**ATLANTIC YARDS COMMUNITY DEVELOPMENT CORPORATION**

**Meeting of the Directors**

**SUBJECT:** Brooklyn (Kings County) – Atlantic Yards Land Use Improvement and Civic Project

**REQUEST FOR:** Authorization to Recommend that Empire State Development’s Directors Approve Open Space Concept Design Presentation Modifications to Open Space Design Guidelines; and Authorization to Take Related Actions

FIGURE 2.1, revision1

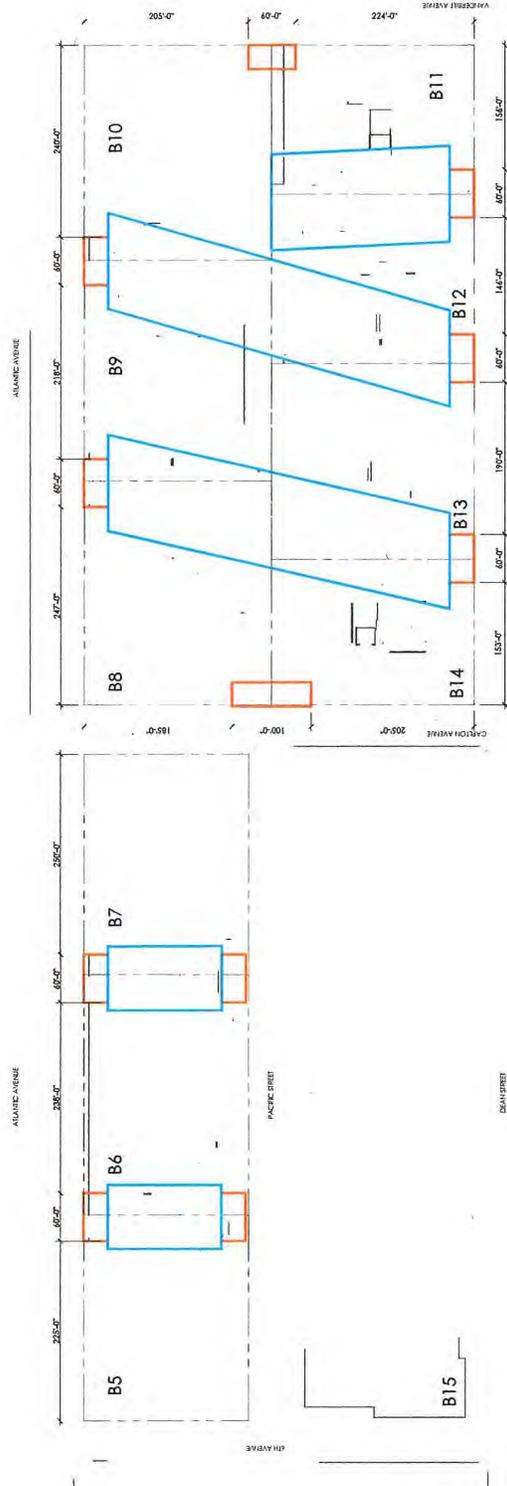
3. Major North-South Walkways. Major North-South Walkways shall link the Primary Access Points to the Major East-West Walkway described in Section 4 in the locations shown in Figure 2.1. The width of the Major North-South Walkway zones as shown in Figure 2.1 shall be unobstructed by any building or other structure not part of the open space for a minimum width of sixty feet throughout.

- a. Each Major North-South Walkway shall include a clear unobstructed pedestrian walkway with a minimum width of 16 feet, which path can split into two or more pathways at any point along its length provided that the resulting pathways each provide a clear unobstructed width of not less than 12 feet.

FIGURE 2.2, revision1

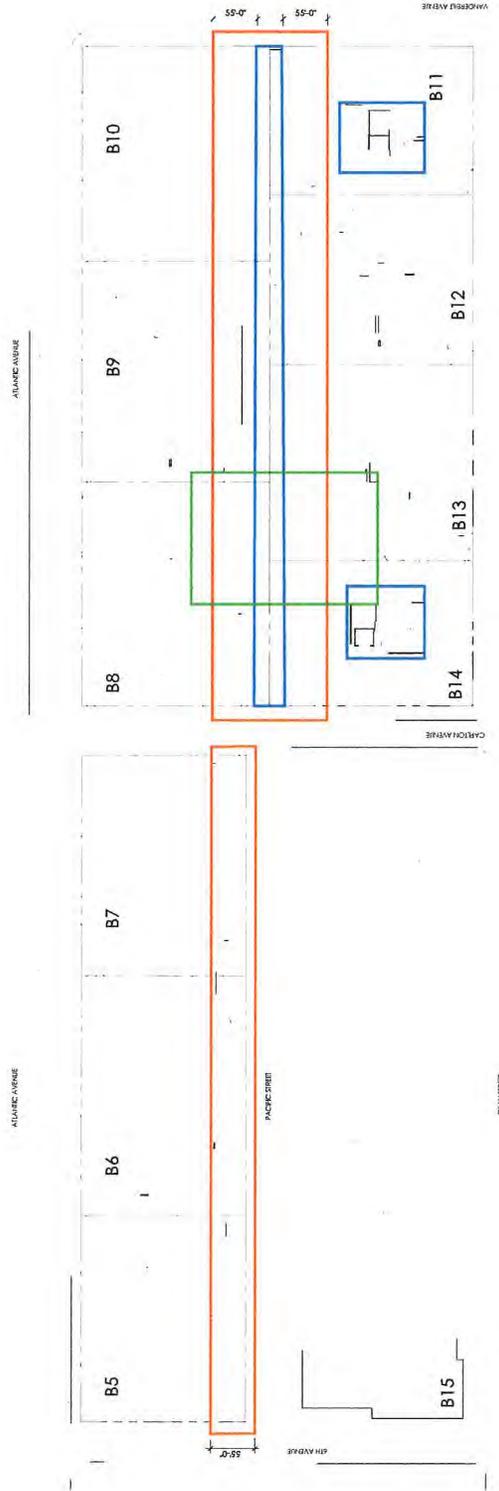
1. Water Feature: Delete paragraph 5b(i) and insert "The open space shall include water features with a minimum surface area of 0.22 acres. Water features shall comply with all applicable rules and regulations." The passive viewing pond of 0.30 acres would be replaced with dispersed distribution of water in the landscape, with water gardens, interactive skim/play areas, and a water rill that runs along the unifying linear lawn on the former Pacific Street roadbed. A skim fountain would be between sites B9, B10, B11, and B12, with approximately 0.01 acres falling within B12.

2. Water Feature Boardwalk: A boardwalk integrated with the passive viewing pond also would be eliminated, with the deletion of paragraph 5b(i).
3. Seating: At paragraph 6a(vi), delete "25%" and insert "35%". The maximum amount of seating that may be backless would increase to 35% from 25%. Permitting a maximum of 35% backless seating would facilitate a design that is responsive to the variety of seating conditions sought by the public. Where passive and active programming is focused adjacent to and along the West-East promenade, a greater concentration of backed seating is anticipated. The design of the North-South walkways and tertiary paths are less formalized and will primarily facilitate movement. Mixed seating opportunities – wide edges, steps, graded slopes, and moveable furniture (backed) – allow a response to this condition; one that is fun, flexible, and interactive.

- **Water Feature Zones**  
Water Features with a minimum combined surface area of 0.20 acres shall be located within the Water Feature Zones
- **Main Lawn Zone**  
A Main Lawn with a minimum size of 0.25 acres shall be located within the Main Lawn Zone
- **Major East-West Walkway Zone**  
The entirety of the Major East-West Walkway shall be located within the Major East-West Walkway Zone

FIGURE 3.1, revision1

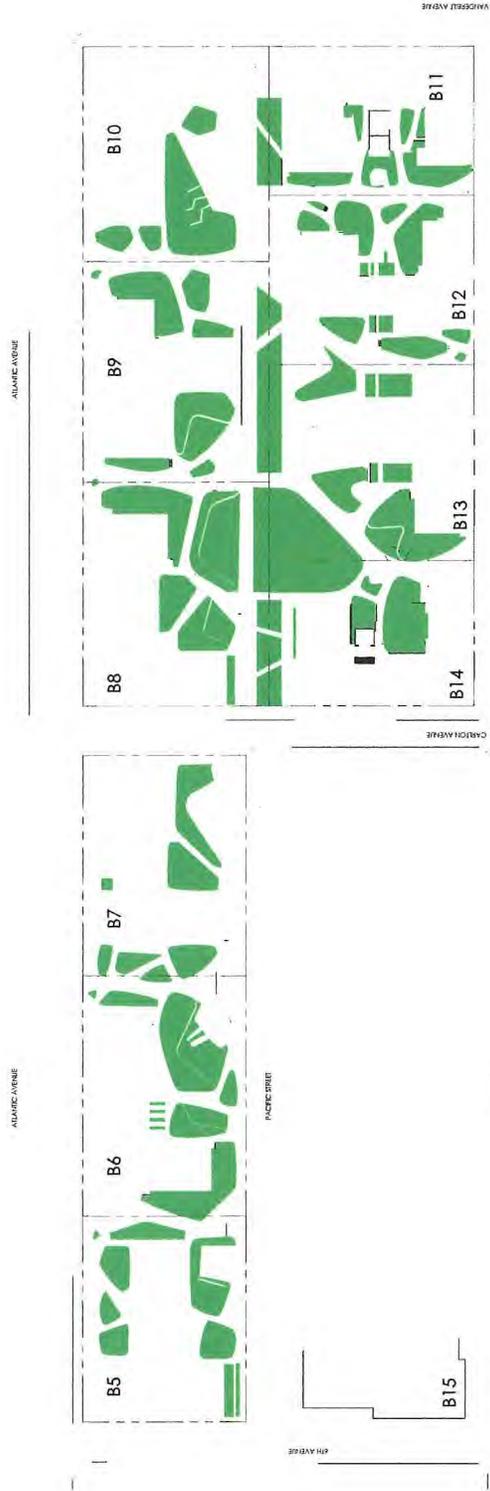
4. Walkways: The total acreage consumed by walkways would reduce from 4.62 acres to 3.65 acres. The bulk of that reduced acreage would be used for planted areas (see 5 below). This change would decrease the amount of paved open space and increase the amount of planted open space.

5. Planted Areas: At paragraph 6d(i), delete "2.6" and insert "3.5". At paragraph 6d(ii), delete ".75" and insert "1.0". At paragraph 6d(iii), delete "1.25" and insert "1.20"; delete "1.85" and insert "2.50". The maximum acreage of open space planted areas

would increase from 2.6 acres to 3.5 acres, mostly by utilizing the reduced walkway areas.

- i. A minimum of 2.0 and a maximum of ~~3.52~~.6 acres of the required publicly accessible open space acres shall be planted areas.
- ii. Between 0.6 and ~~1.00~~.75 acres of the required Planted Areas shall be located on Block 1120.

- iii. Between ~~1.20~~.25 and ~~2.50~~.85 acres of the required Planted Areas shall be located on Block 1121/1129, such amount to be inclusive of the Main Lawn.

FIGURE 3.3, revision1

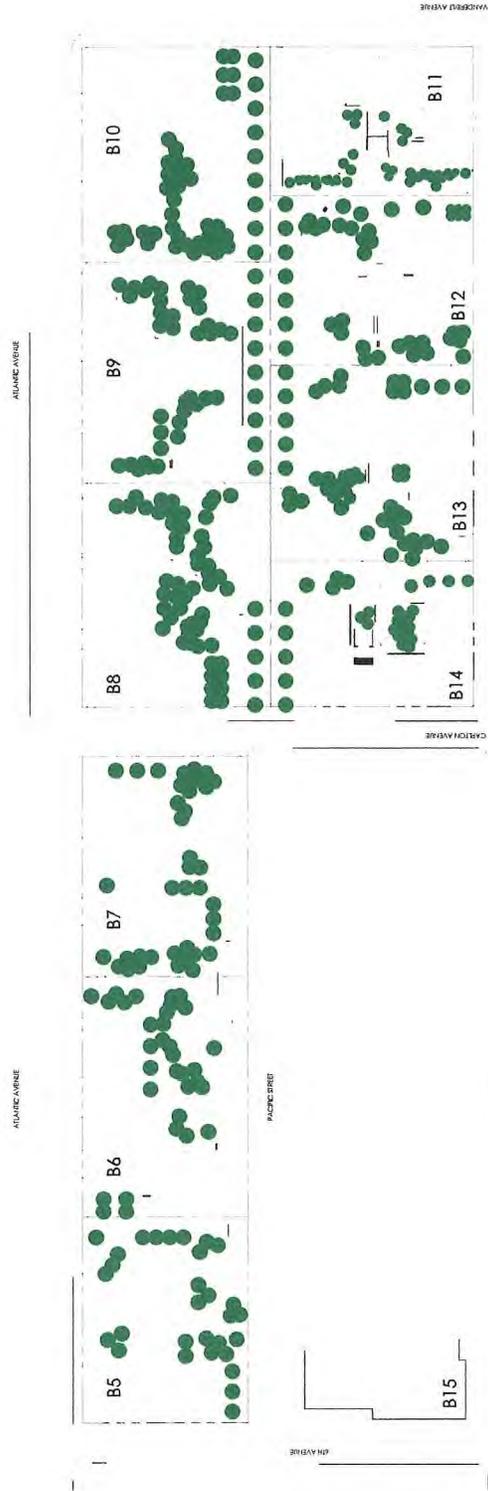
6. Planted areas, Canopy Trees: Paragraph 6d(v) would be amended by inserting at the end of the first sentence, “with the exception of the Major East-West Walkway at the large open lawn area bordered by sites B8, B9, B13, and B14.” This will permit a visually unobstructed main lawn to serve as a unifying focal point for active and passive use.
7. Open Space Diagrams: Delete the Open Space Diagrams attached to the Design Guidelines at Appendix 2a (pages 87 to 93) and insert the attached Exhibit E. Delete the Open Space Illustrative Phasing Diagrams attached to the design Guidelines at Appendix 2b (pages 94 to 104) and insert the attached Exhibit F. The open space for each individual building will be completed, as shown on the Illustrative Phasing Diagrams, as each individual building is completed, as previously required.
